**City of Bellevue
Development Services Department
Land Use Division**

Proposal Name: Bel-Green Master Development Plan

File Number: 08-136677-LP

Decisions Included: Master Development Plan approval and SEPA Determination.

site concept plan 01 revised

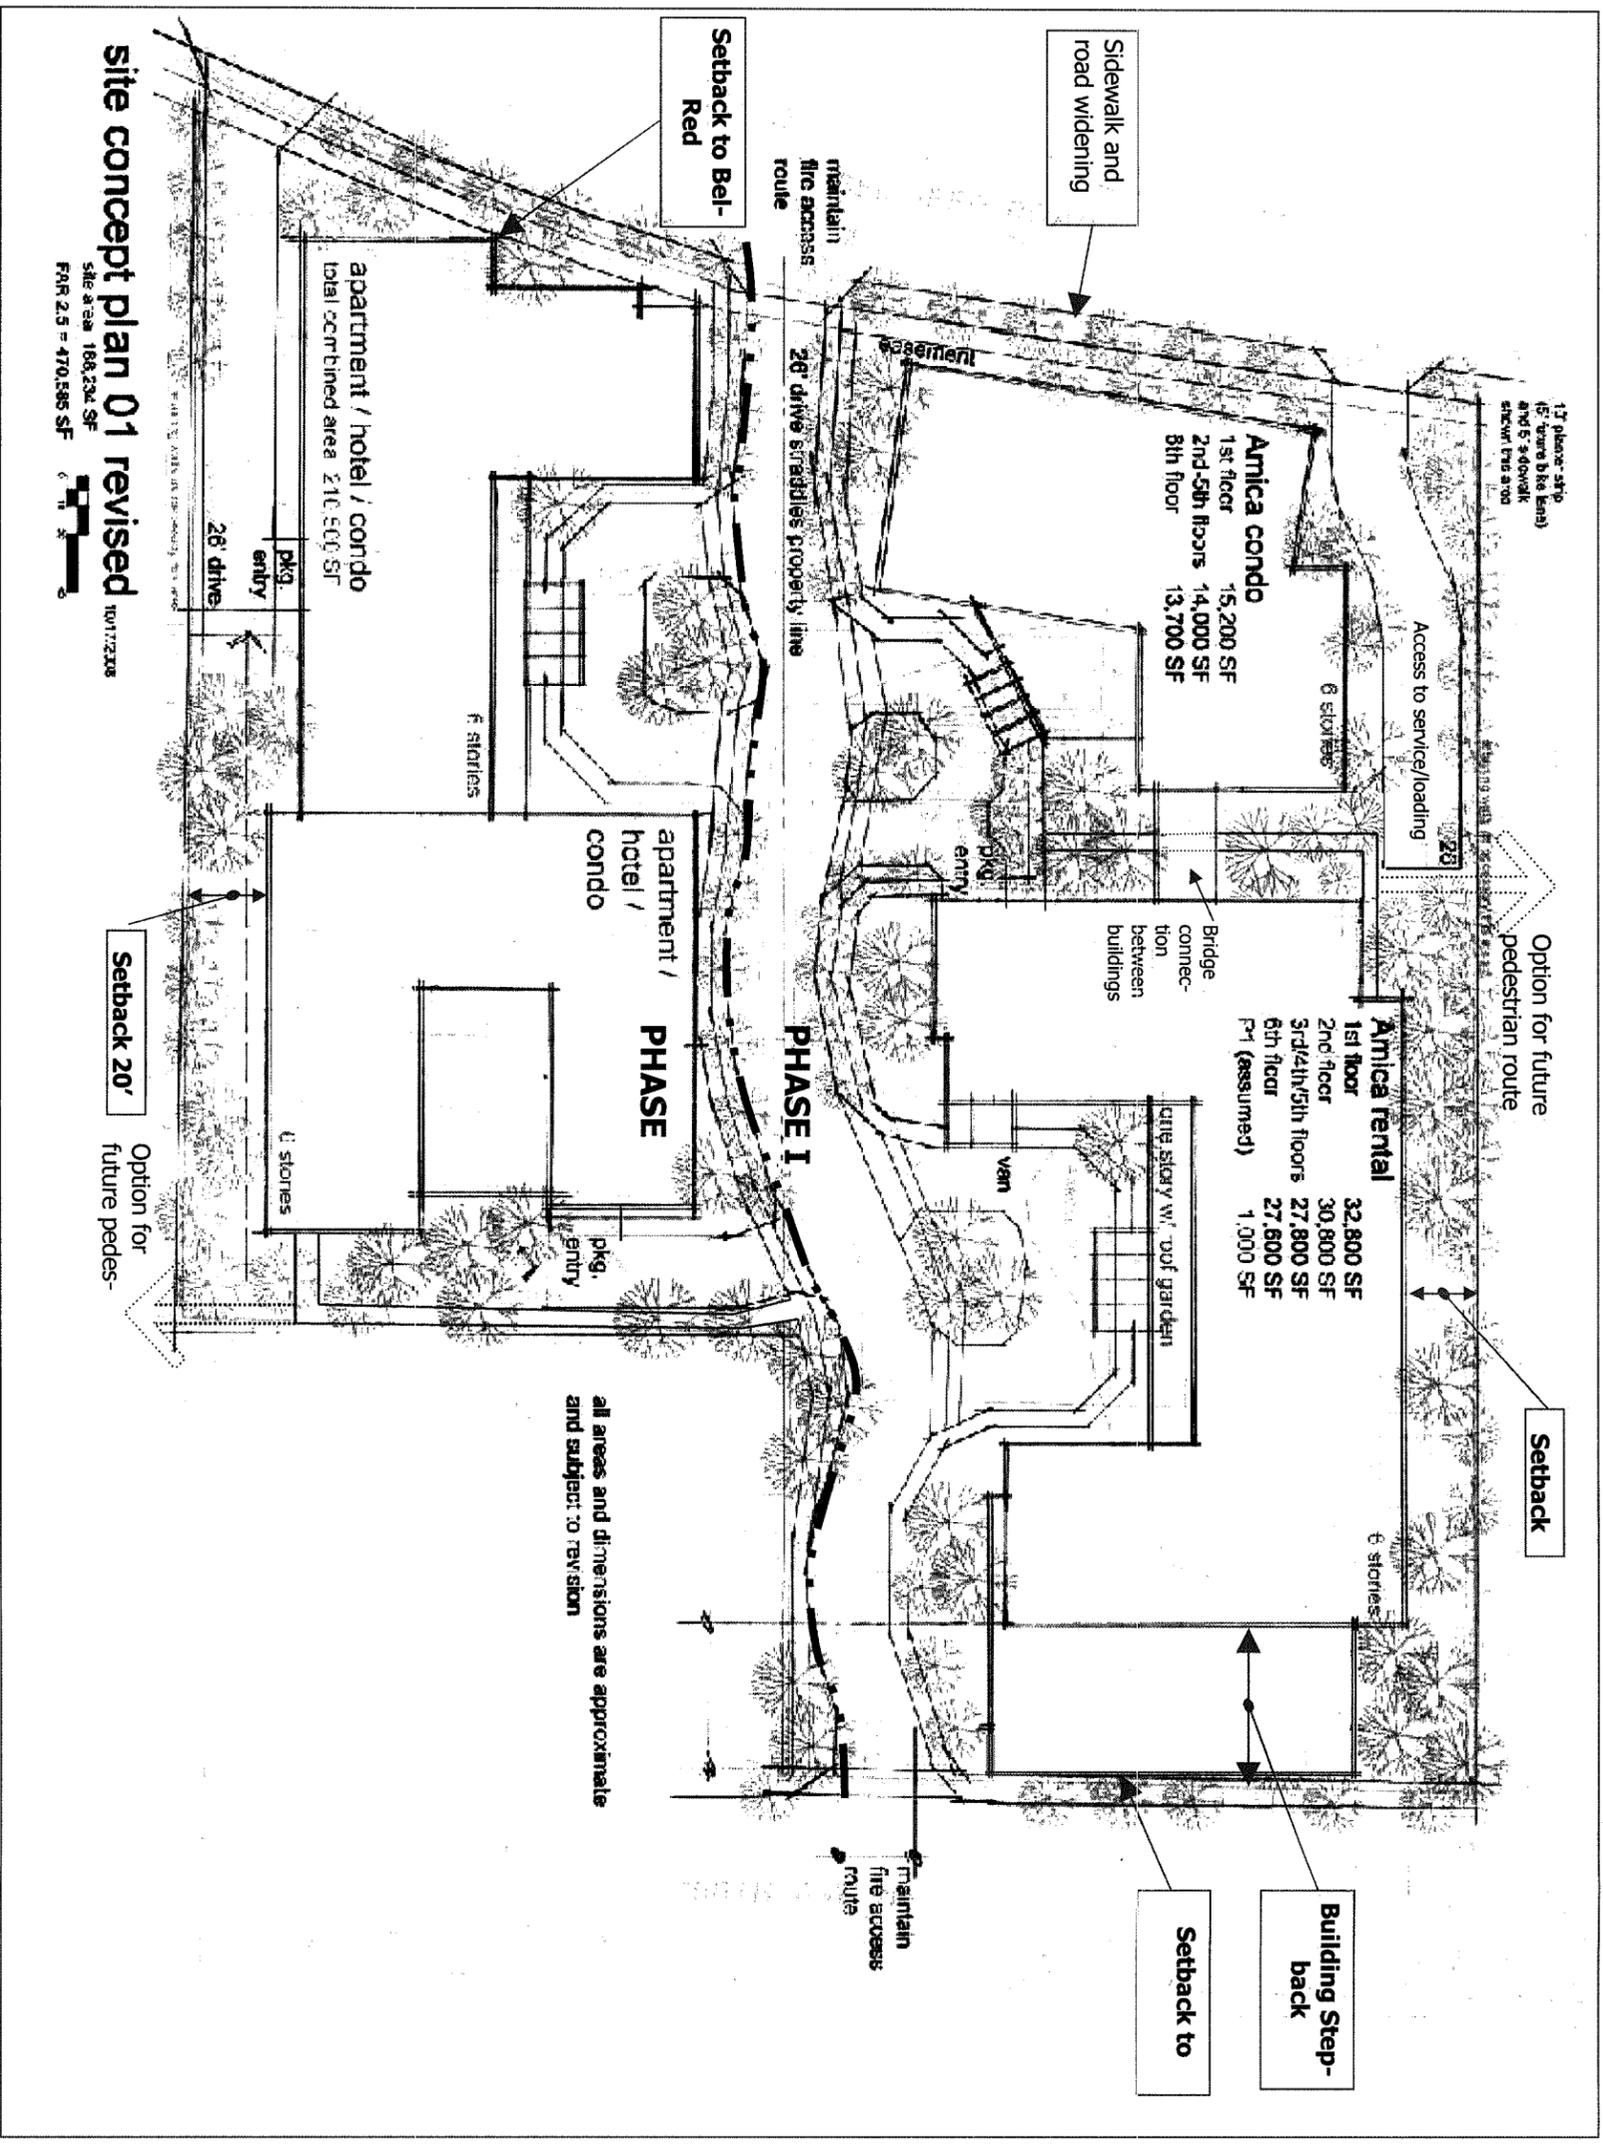
As a condition of this decision, any future proposal based on the MDP must include a north-south pedestrian connection through the site, linking the Sherwood Shopping Center and the Walgreens site. The connection must be dedicated park space and include landscaping, seating nodes, pedestrian-oriented paving and lighting. The connection must be a minimum width of 10-feet. The connection alignment and design shall be established with the Design Review decision for Phase I and constructed in phases per the City-approved phasing plan.

Each phase of the MDP shall include a public north-south pedestrian connection with open space(s) extending through the project area, such that upon completion of both phases there is a continuous public connection with open spaces through the entire site. The connection and open spaces shall total a minimum of 15,825 square feet. The design for the connection/spaces shall be consistent with the Bel-Red Parks and Open Space Plan and meet the applicable design criteria. The connection/open space(s) shall be dedicated to the City of Bellevue Parks Department for public use and enjoyment. Alternatively, the applicant may make a fee-in-lieu payment of \$15 per SF of bonus area.
